CITY OF ALBUQUERQUE

Re: Maher Warehouse, 4120 Culter Ave. NE, Grading and Drainage Plan
Engineer's Stamp dated 05-16-08 (H-17/D086A)

Re: Maher Warehouse, 4120 Culter Ave. NE, Grading and Drainage Plan
Engineer's Stamp dated 04-16-08 (H-17/D086A)

Based upon the information provided in your submittal received 10-30-15, the above referenced plan cannot be approved for Building Permit until the following comments are addressed:

REQUIRED AREA: 6,618.5 GSF

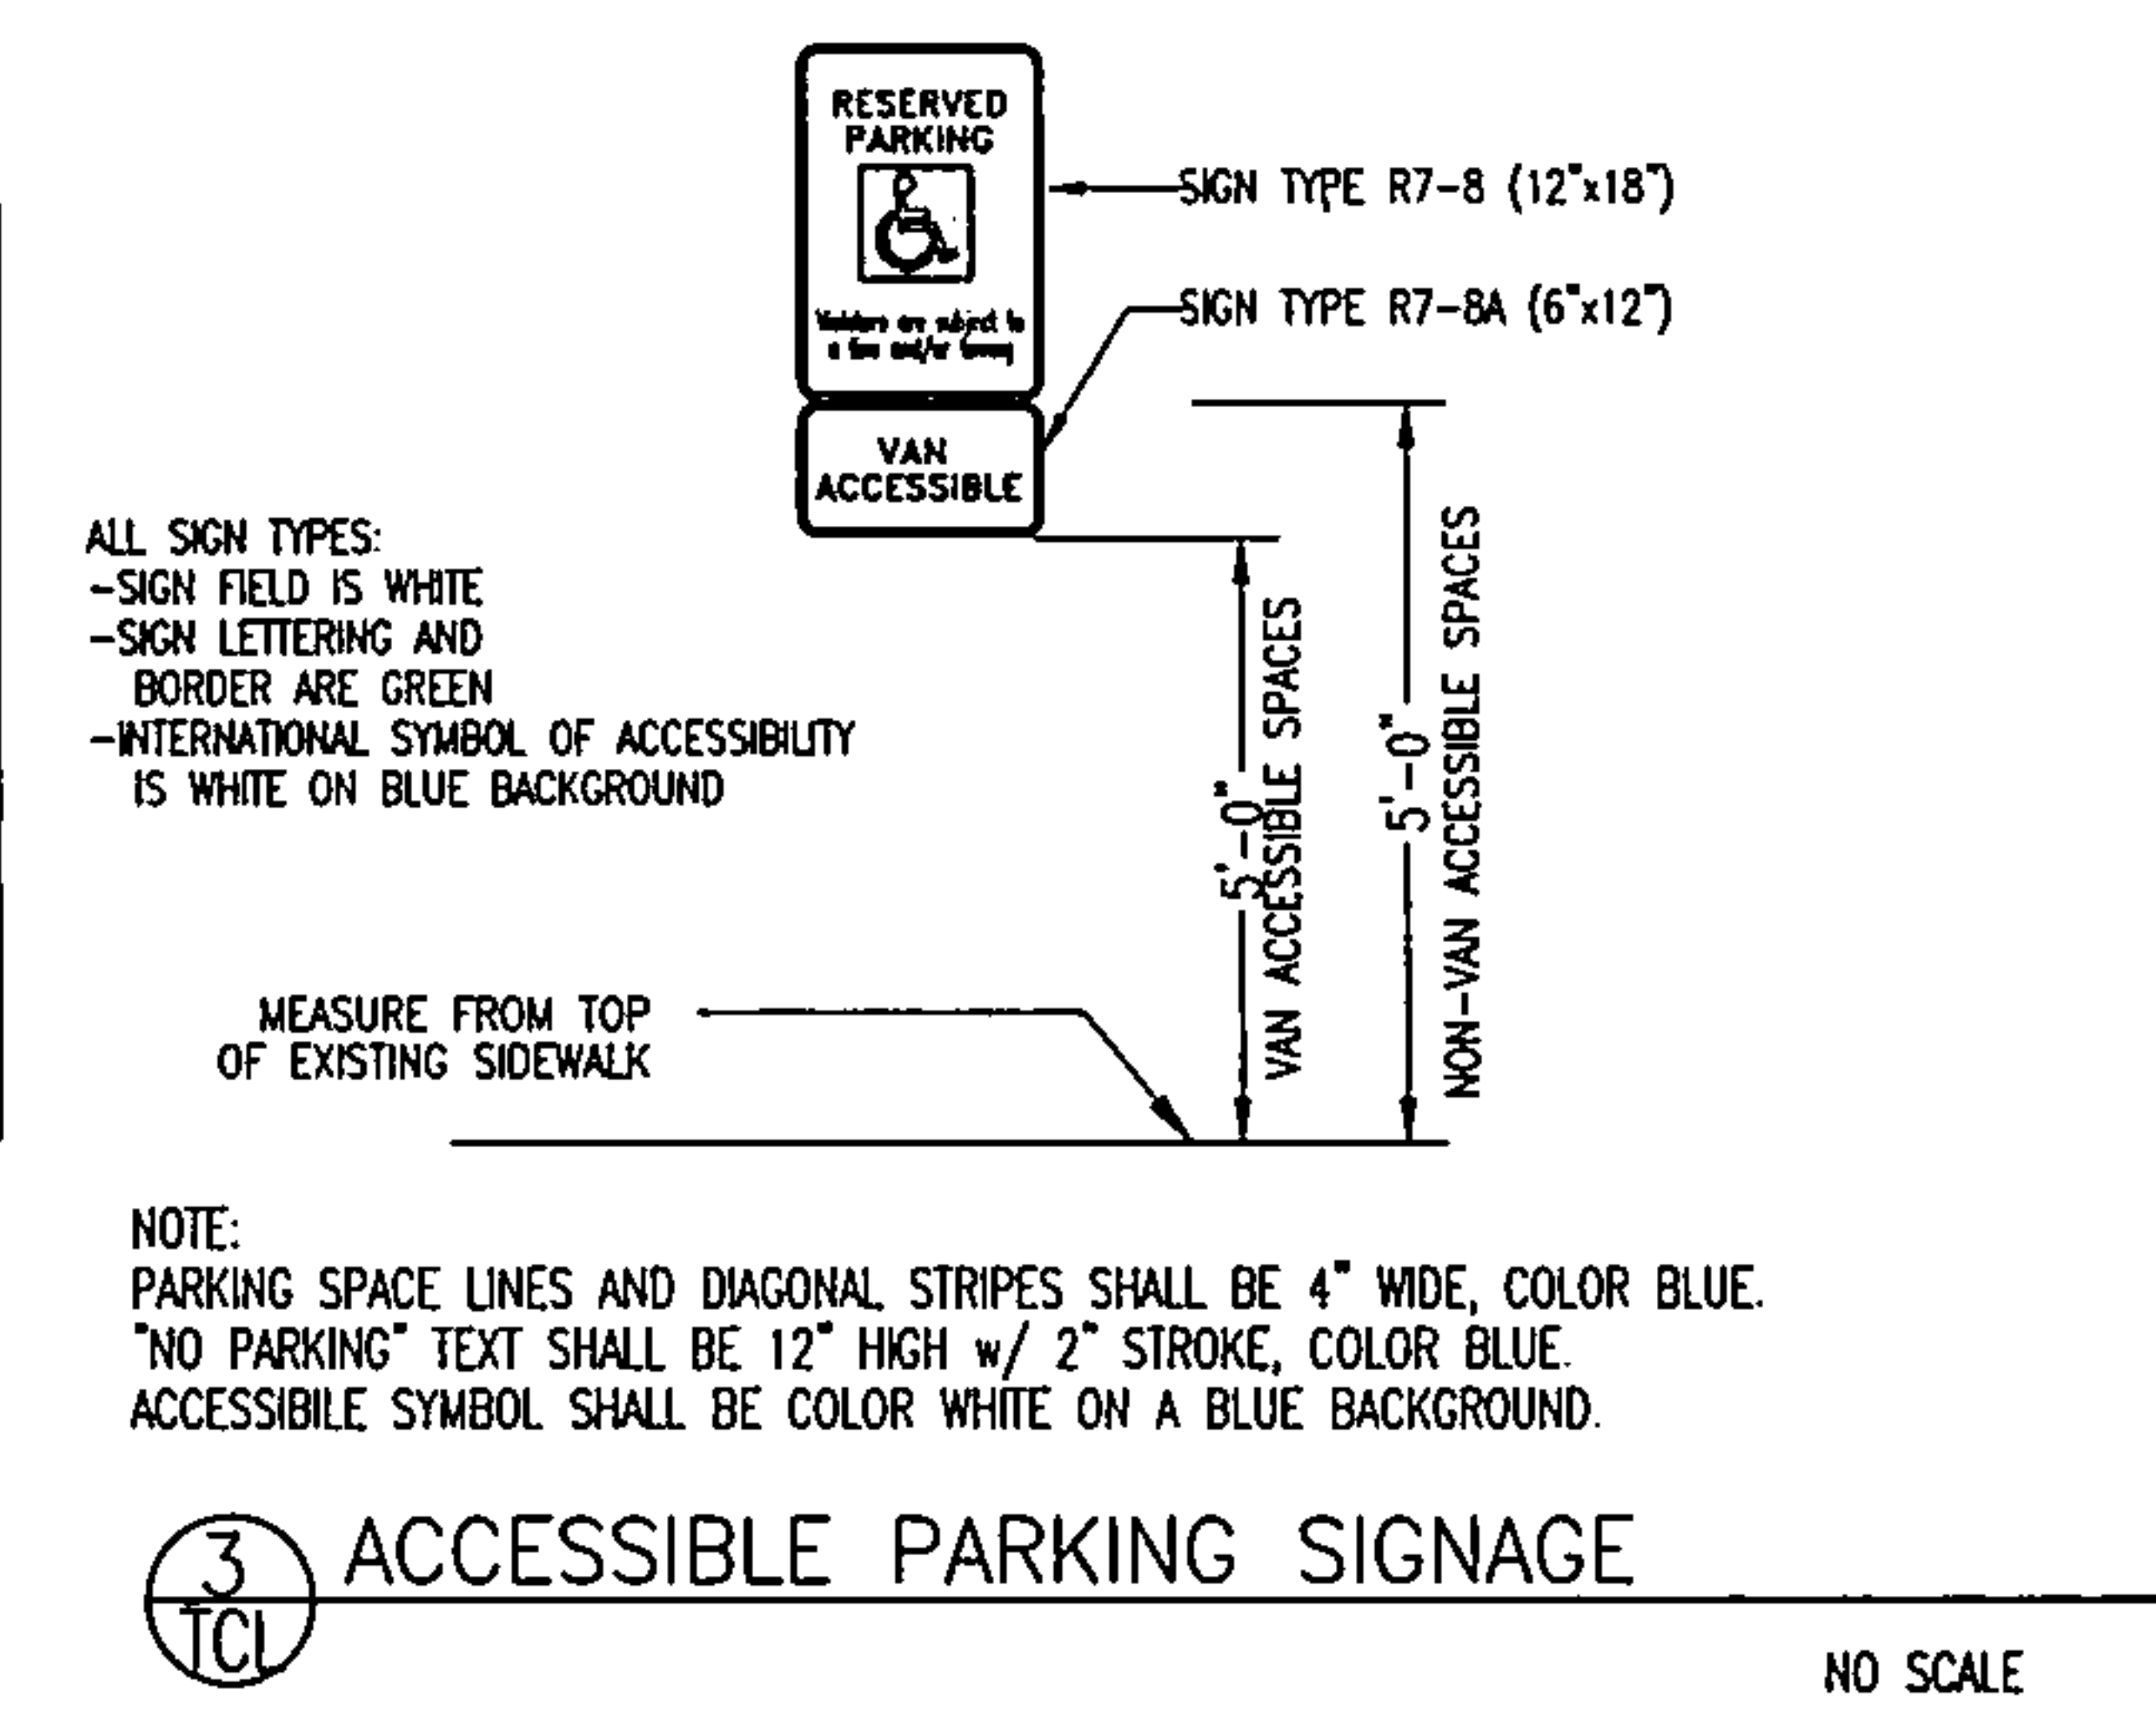
Attached is a marked up drawing of your submittal, notating the ADA sidewalk in question. Per DPM an ADA accessible pathway is required from the public ROW. You are notating that there is a step. Also, the resubmittal will need a new Stamp Date.

** Detail ADA Reg RAMP, specifying slope*
